3-C-25-HZ
APPLICATION FOR CERTIFICATE OF APPROPRIATENESS

**216 Canler Ave. 37921**
Mechanicsville H

Level III Construction of New Primary Building

CANSLER AVE DUPLEX NEW RESIDENTIAL CONSTRUCTION

6 ARTICULATED WINDOW & DOOR TRIM DETAIL
NTS

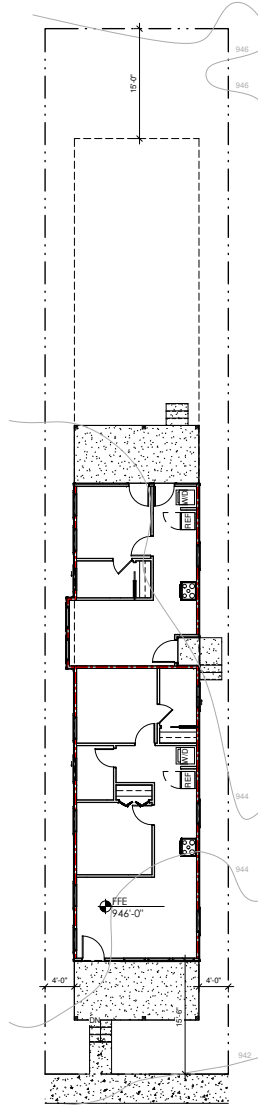
Elevation drawings reference 1 by 4 wood trim, while the trim profile drawing indicates fiber cement siding with a narrow sill that may not be proportionate to historic window sill patterns. Final trim material should be consistent with the approved siding material, and projecting window sills should be compatible in design and size to historic window sills.

- 1) front porch to feature wood tongue-and groove flooring and a wood beadboard ceiling;
- 2) final window materials to be approved by Commission, with final specifications submitted to staff for approval;
- 3) window trim to be compatible in material with final material selection, and feature projecting sills compatible in design and proportion with historic windows;
- 4) front door specifications to be submitted to staff for approval;
- 5 Commission and neighborhood to discuss and approve final exterior siding material.

1 FRONT ELEVATION
3/16" = 1'-0"

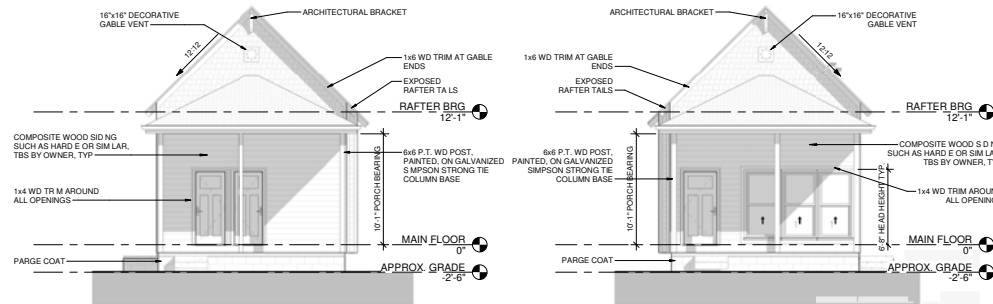
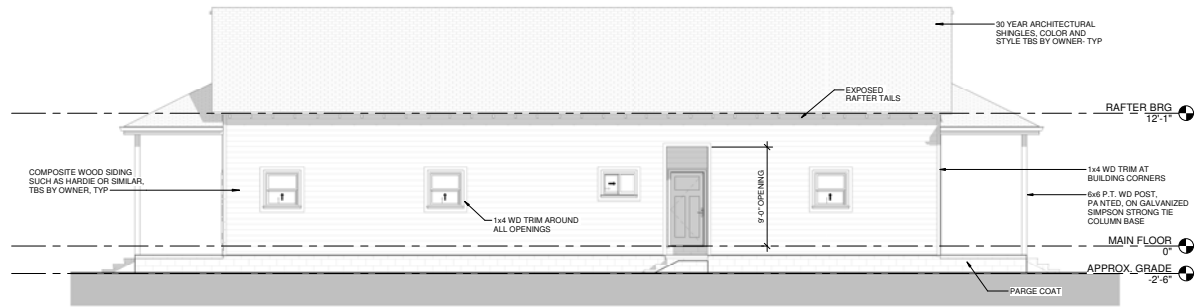
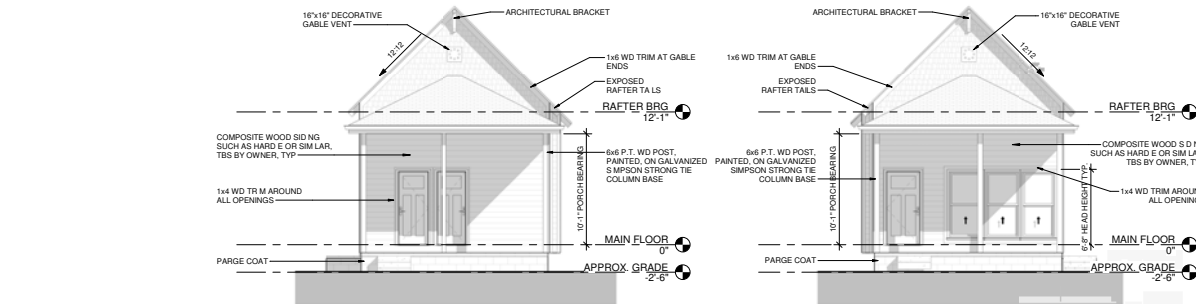
10. Guidelines recommend that new buildings use materials consistent with the street and the surrounding neighborhood. Materials are not specified for the proposed windows. The applicant has revised the initially proposed slider windows, to small double-hung windows. The Commission should discuss the overall size and proportion of the double-hung windows in relation to historic windows in the neighborhood.

Vinyl windows are not appropriate in a historic district; alternative materials could include fiberglass or aluminum-clad wood, based on the preference of the Commission and the neighborhood. The applicant should clarify window materials for the Commission's approval.
